ADDENDUM NO. 1
WORKFORCE ADDITION
ARKANSAS TECH OZARK CAMPUS
OZARK, ARKANSAS
Project No. 25036

October 29, 2025

The proposed Contract Documents, dated October 20, 2025, have been modified as follows:

4
A5.4 CANOPY EDGE DETAIL
3" = 1'-0"

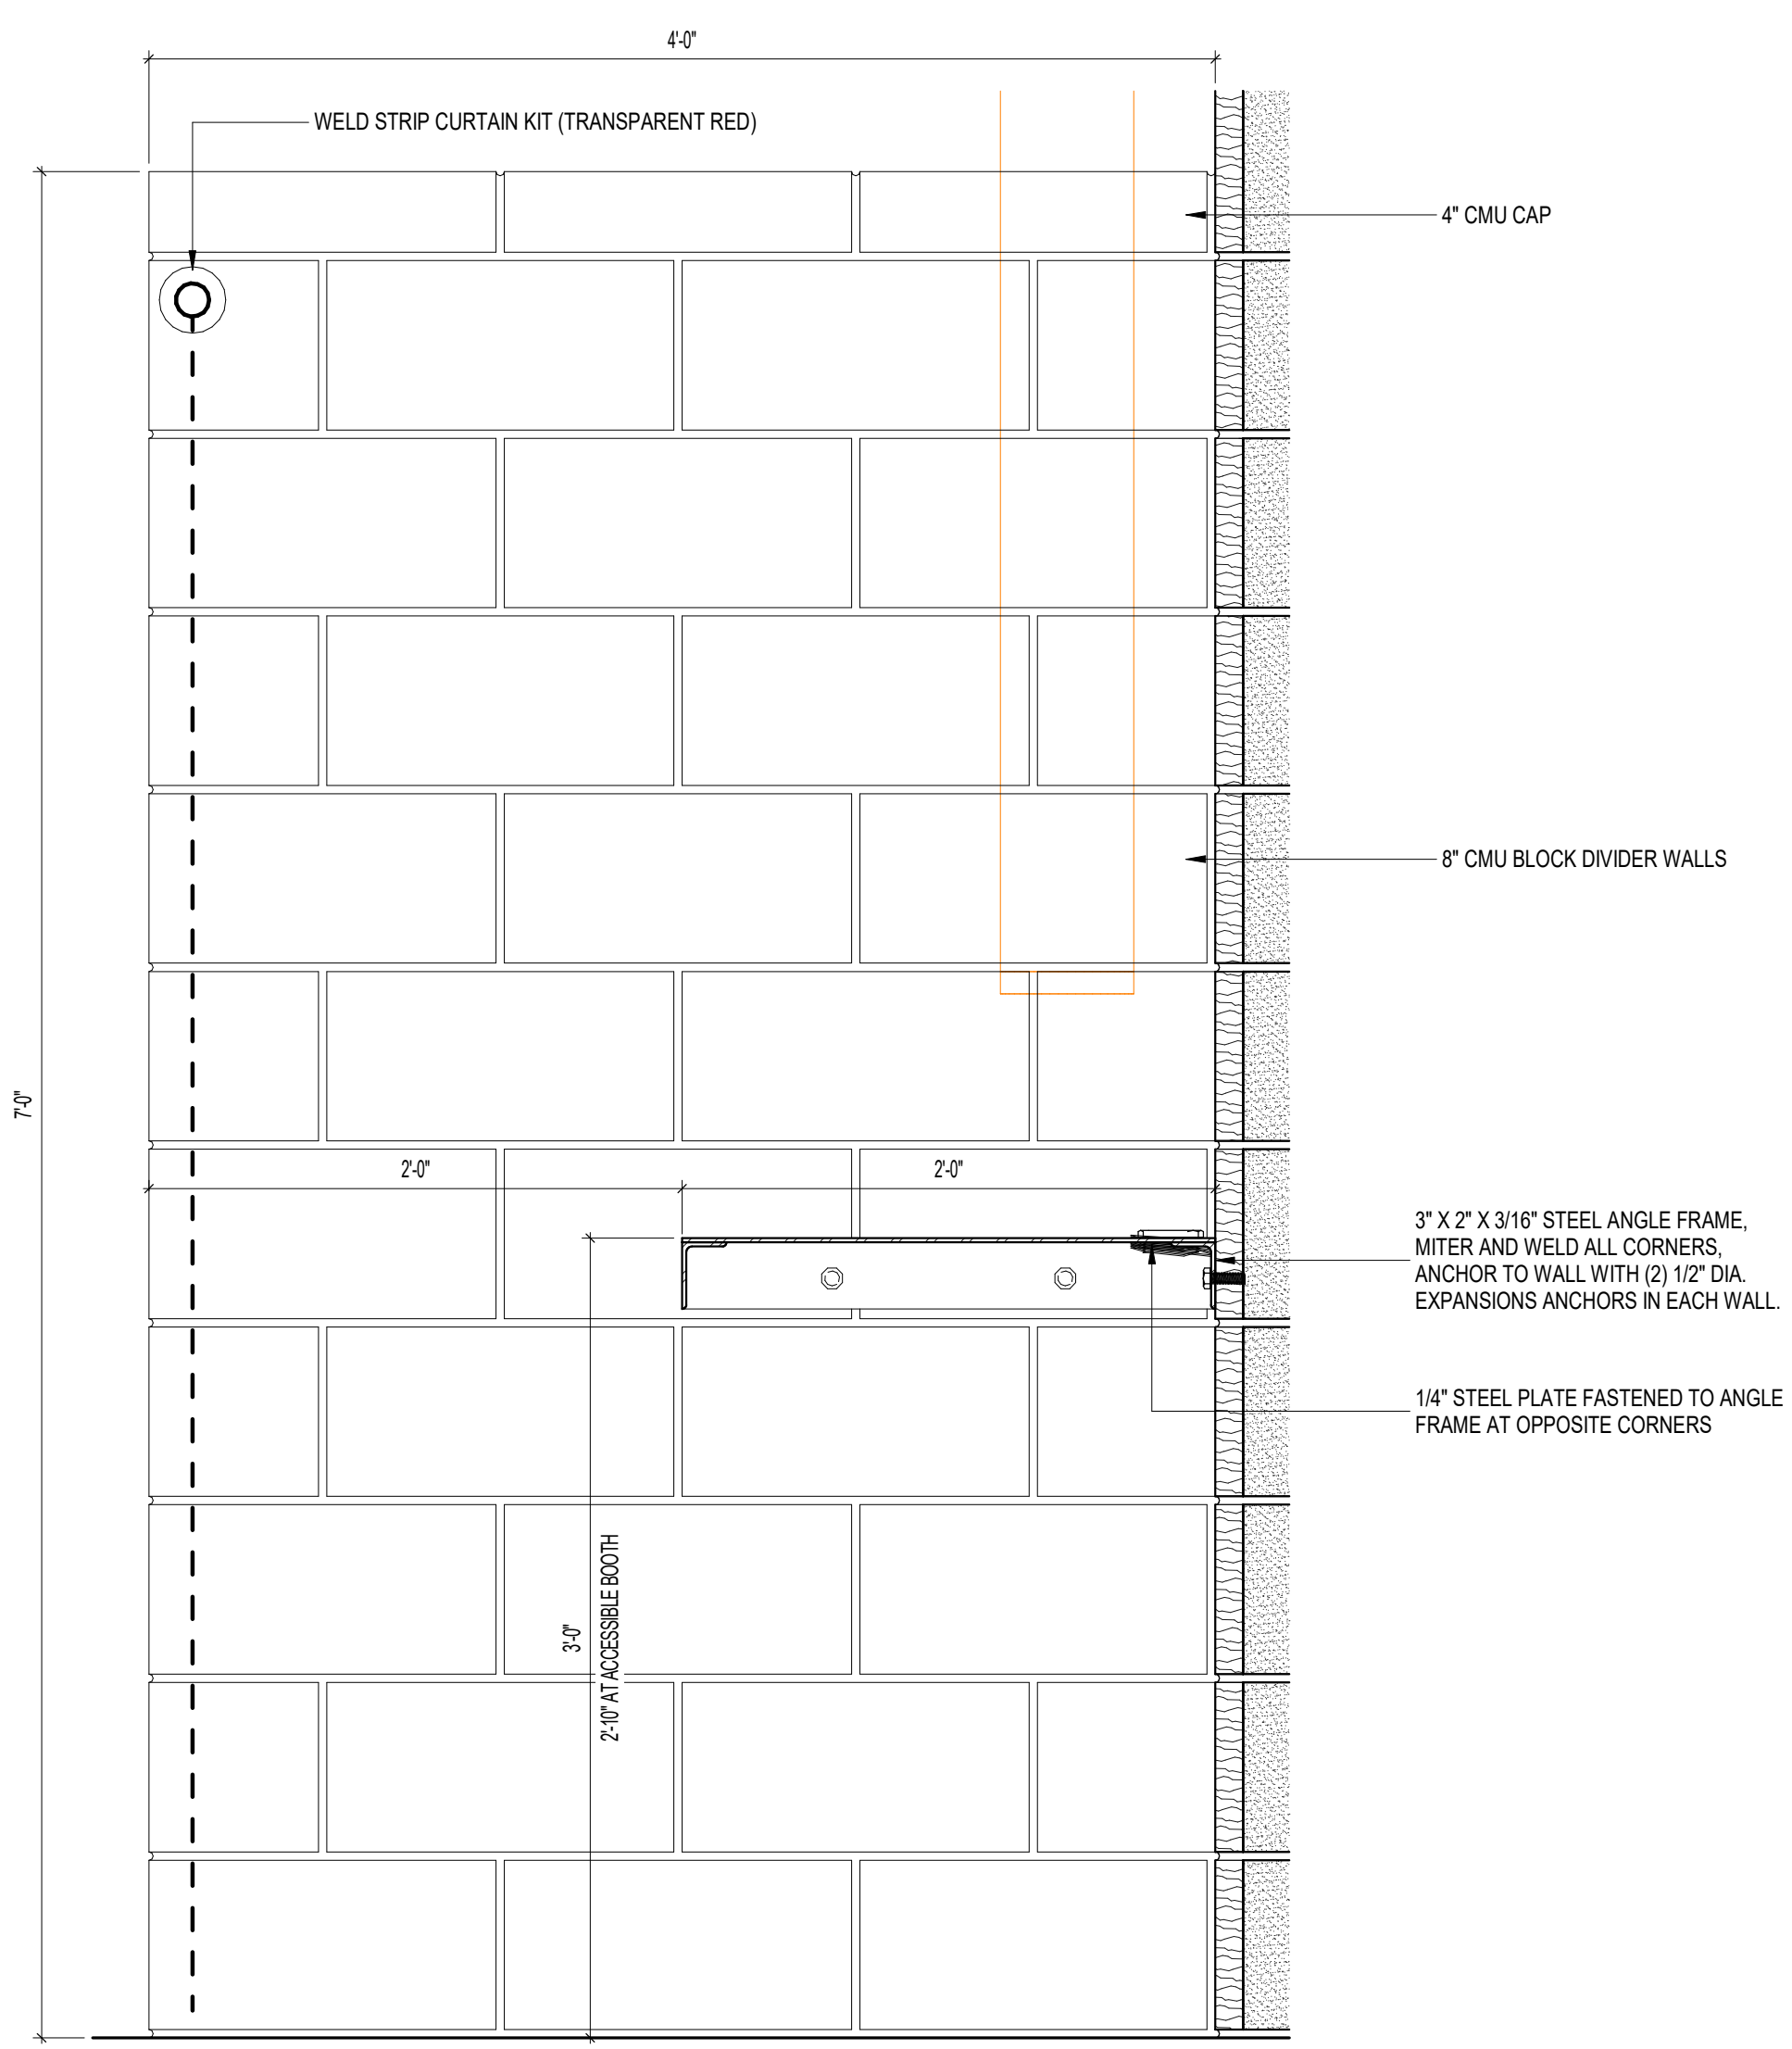
Item #5: Sheet A5.4, Revised 2025 10-29 (attached): See revised canopy edge detail 4/A5.4.
